Arlington Conservation Commission

DEP #091-0356: Notice of Intent: Thorndike Place (Continued from 09/05/2024).

RE: Thorndike Place, Dorothy Road, Arlington, Massachusetts – Response to GZA Peer Review of Stormwater Mound Evaluation and Design Groundwater Elevation

Re: Peer Review of Stormwater Mound Evaluation and Design Groundwater Elevation
Proposed Thorndike Place Residential Development
Arlington, Massachusetts

Ground- Distance from
water center of basin
Mounding, in in *x* direction, in
feet feet

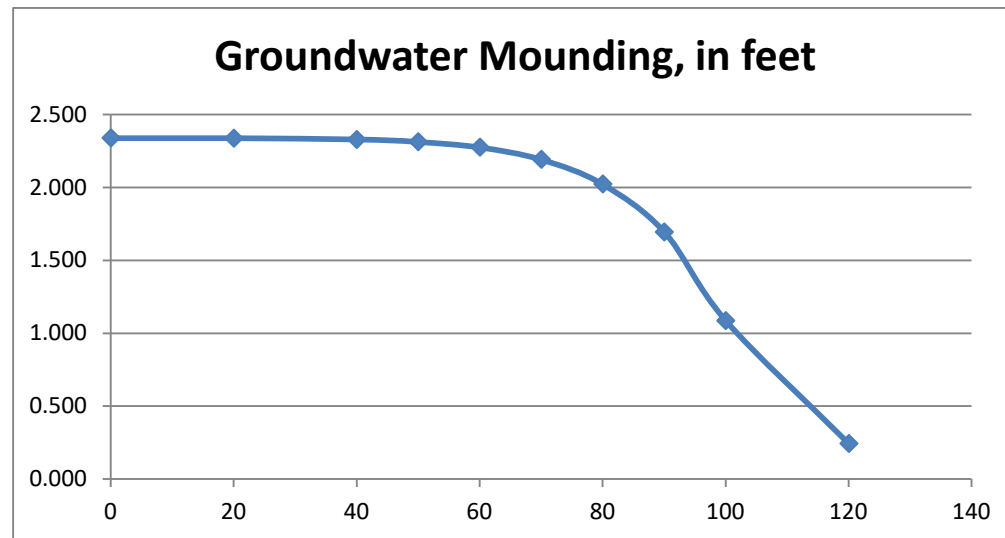
If the stormwater infiltration system was instantaneously filled with the required recharge volume of 1,638 cubic feet and then discharged out of the system at the Kv design rate of 0.27-inches per hour (0.54 feet per day), it would take 8.96 hours to drain (i.e., 0.374 days). GZA's initial groundwater mound analysis using the Hantush method and the values listed above (Large Infiltration System V-1) is provided in Appendix B and indicates that maximum groundwater mound would be 2.27 feet.

However, it is more likely that the required recharge volume would flow out of the infiltration basin over the duration of one day. GZA's second groundwater mound analysis (Large Infiltration System V-2) assumed the same conditions as the Large Infiltration System V-1 except the duration was one day and the applied recharge was 0.2014 feet per day. The resulting maximum groundwater mound would be 1.85 feet (see Appendix B).

It is GZA's opinion that the Required Recharge Volume of 1,638 cubic feet can be infiltrated into the ground, without causing excessive groundwater mounding. However, for stormwater volumes larger than 1,638 cubic feet the rate of groundwater infiltration will decrease significantly, and the groundwater mound will extend into the bottom of the infiltration system.

ATTACHMENT A
THORNDIKE PLACE NOTICE OF INTENT
GRADING & DRAINAGE PLAN, SHEET C-104
REVISION 1 DATED 9/12/24

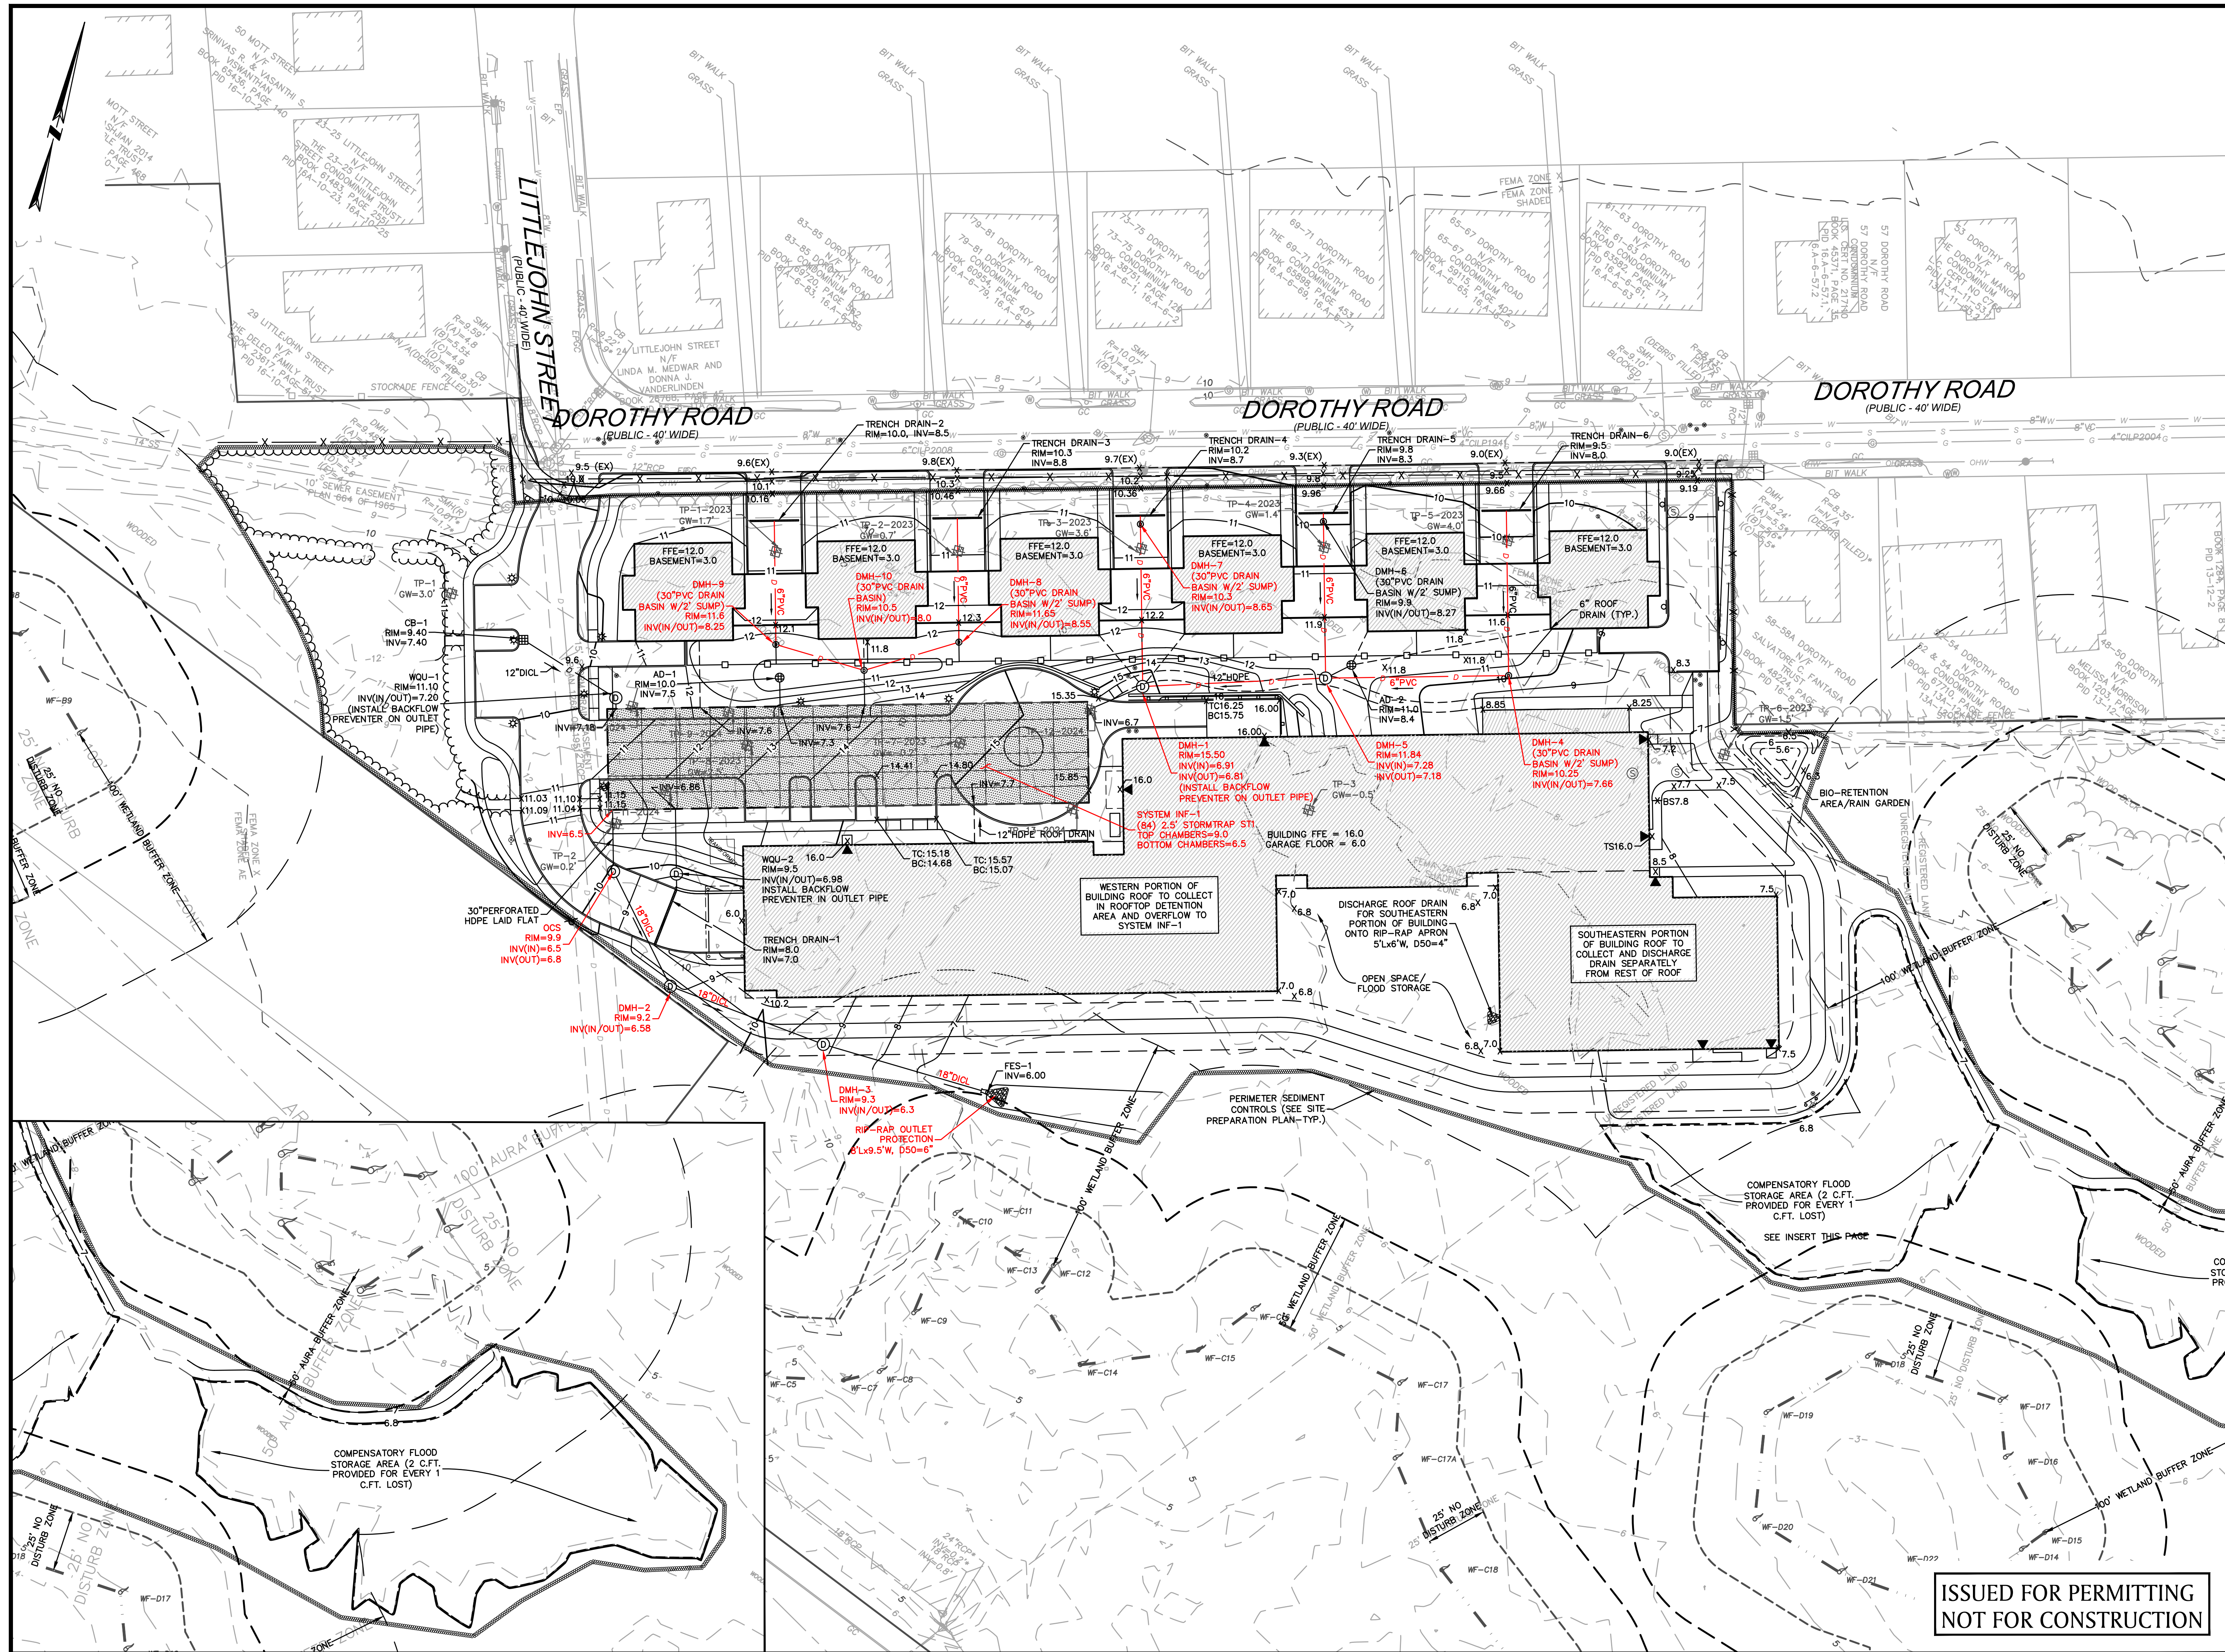
Although GZA believes the Required Recharge Volume of 1,638 cubic feet can be infiltrated into the ground without causing excessive groundwater mounding, larger volumes of storm water runoff will not drain within the required 72-hour period. It is GZA's opinion that for stormwater volumes larger than the Required Recharge Volume, the rate of groundwater infiltration will decrease significantly, and the groundwater mound will extend into the bottom of the large main infiltration system. In GZA's opinion both the large main stormwater infiltration system and the smaller driveway stormwater infiltrations systems would need to be redesigned to account for the impacts of groundwater mounding during large storm events and to meet the MassDEP Stormwater Manual's maximum allowable drainage standard of 72-hours.

- Infiltration System 1 has been revised to a 2.5-foot StormTrap system from the previous system height of 3-feet. The elevation of the bottom of the system has been raised 0.5 feet higher to elevation 6.5, and the outlet control for this system has been revised. These revisions allow for infiltration of the required recharge and water quality volumes but minimizes the amount of recharged stormwater during larger storm events.

- Various pipe sizes and slope have been revised to accommodate the changes detailed above.

Calculations for outlet protection sizing, post-development peak runoff rates, groundwater recharge, groundwater mounding, and total suspended solids (TSS) removal have been performed and are attached along with the revised Grading and Drainage Plan for the Project.

As described above, we have revised the stormwater management system to respond to GZA's concern. Applicable plans and calculations are attached.
